Informal document No. **GRE-68-20**
(68th GRE, 15-18 October 2012,
agenda item 4(c)(i))

Comments on GRE/2012/27(Lighting & Signalling WG)

Headlamp Initial Aiming

60m
forward
Visibility

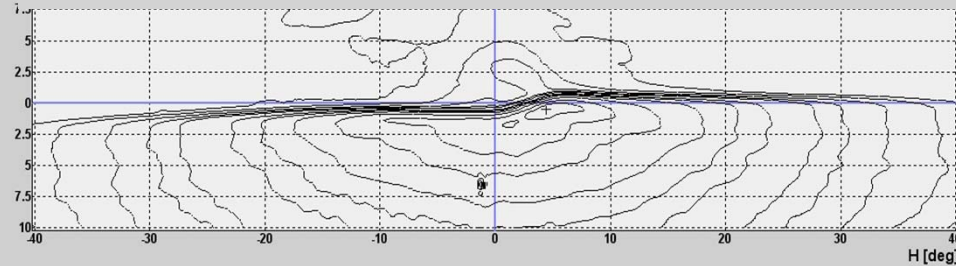
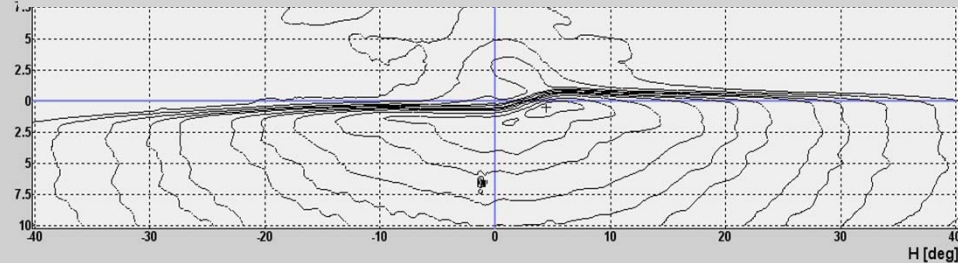
Low gradient through the cutoff = less glare sensitivity to initial aiming tolerances

- Both lamps have a theoretical range of 75m
 - Sample 11 has TC4-45 visibility range of 60m
 - Sample 5 has TC4-45 visibility range of 85m

- Both lamps have a theoretical range of 75m
 - Sample 11 has TC4-45 visibility range of 60m
 - Sample 5 has TC4-45 visibility range of 85m
- **Conclusion: theoretical range is a poor measure of real-world visibility**

85m
forward
Visibility

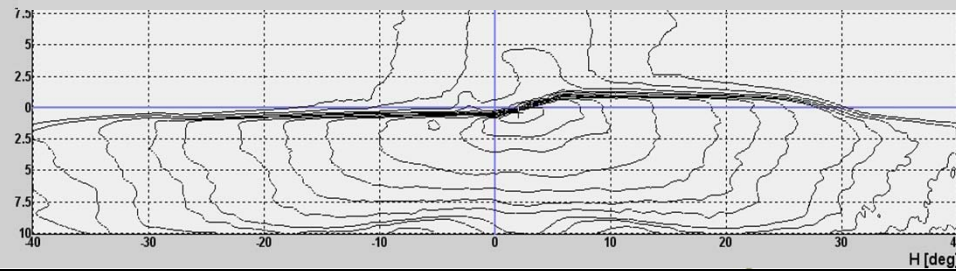
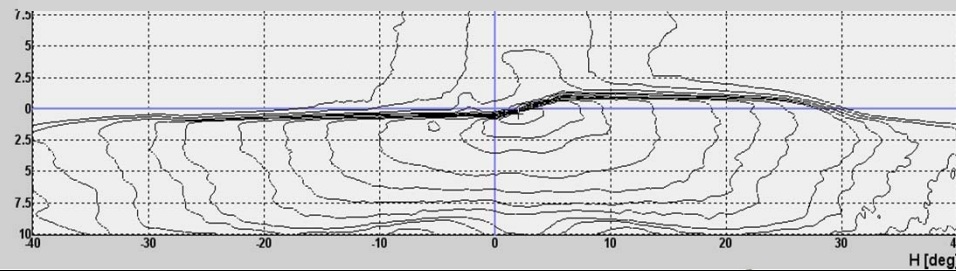
High gradient
through the cutoff =
more glare
sensitivity to initial
aiming tolerances

Tolerance with load levelling

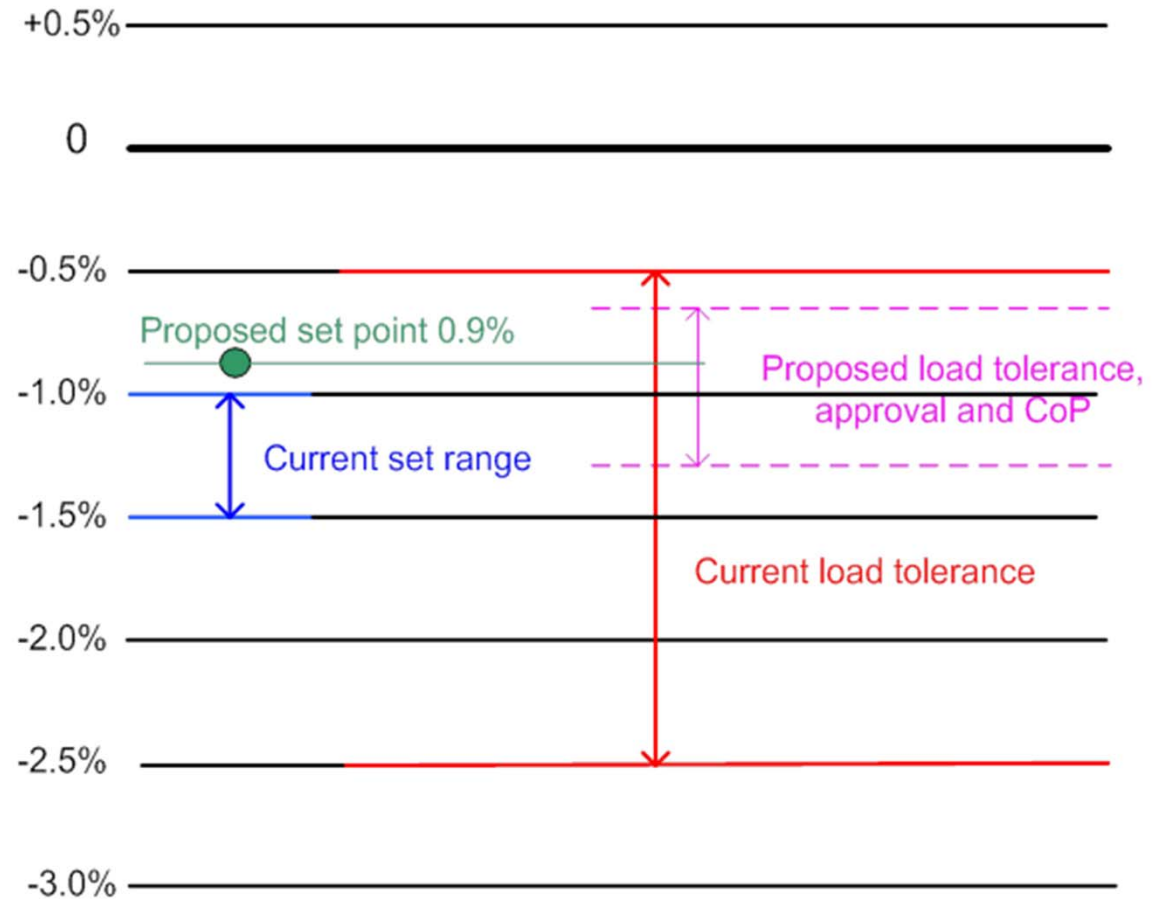
Example for
650mm high
passenger car
headlamp

- To consistently meet CoP requirements, initial aim and levelling system need to be repeatable with a standard deviation of better than 0.1%.
Repeatability of suspension system alone is not this good.
